Access Compliance Report

Public Rights-of-Way

Intersection ID: 13745	Main Street: HAWTHORNE_LN	Cross Street: PARK_DR	Location:	E
ADA ID: BD9A70B2B187	Ramp Type: BlendTrans1	Initial Pass/Fail: Pass	Overall Compliance: No	Severity Score: 0.25

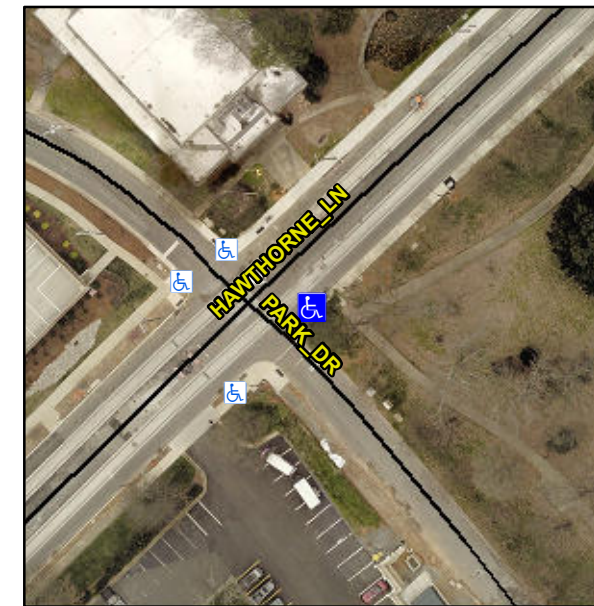
LNDG OS FROM RAMP

R304.5.3

Remove & Replace Gutter.
